Access Compliance Report

Public Rights-of-Way

(Curb Ramps)

Intersection ID: 17758	Main Street: NATIONS_FORD_RD	Cross Street: SOUTHWOLD_DR	Location: NW
ADA ID: 79FC7660A626	Ramp Type: Directional1	Initial Pass/Fail: Fail	Overall Compliance: No
		Severity Score: 1.25

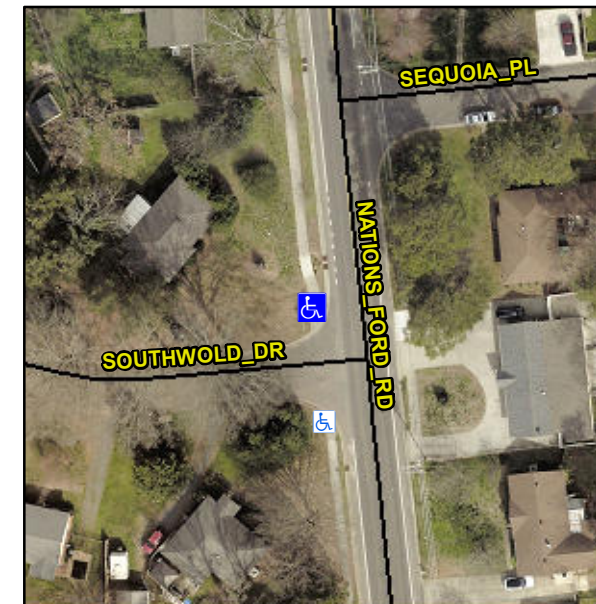
R304.5.3

Compliance	Description	Data	Compliance	Description	Data
N/A	Ramp Length (in)	83.0	N/A	Grade Break?	N/A
Yes	Ramp Width (in)	71.0	N/A	Grade Break Slope (%)	0.0
Yes	Ramp Slope (%)	4.7	N/A	Grade Break XSlope (%)	0.0
No	Ramp XSlope (%)	3.9			
N/A	Flare Type LT	N/A	N/A	Flare Type RT	N/A
N/A	Flare Slope LT (%)	N/A	N/A	Flare Slope RT (%)	0.0
N/A	Flare Traversable LT?	N/A	N/A	Flare Traversable RT?	N/A
N/A	Landing Length (in)	0.0	N/A	DWS Provided?	N/A
N/A	Landing Width (in)	0.0	N/A	DWS Contrast?	N/A
N/A	Landing Slope (%)	0.0	N/A	DWS Length (in)	N/A
N/A	Landing X Slope (%)	0.0	N/A	DWS Full Width?	N/A
N/A	Landing Curb? (Y/N)	N/A	N/A	DWS Offset LT (in)	N/A
N/A	Shared Landing?	N/A	N/A	DWS Offset RT (in)	N/A
N/A	Gutter Ponding?	0.0	N/A	Gutter Slope (%)	N/A
N/A	Gutter Lip Ht (in)	0.0	N/A	Gutter X Slope (%)	N/A
N/A	Painted X Walk1?	No		Road Slope (%)	0.9
	X Walk 1 Direction	To SE		Road X Slope (%)	0.4
	X Walk 1 Width (in)	N/A		Clear Space?	N/A

Remove & Replace Entire Ramp.
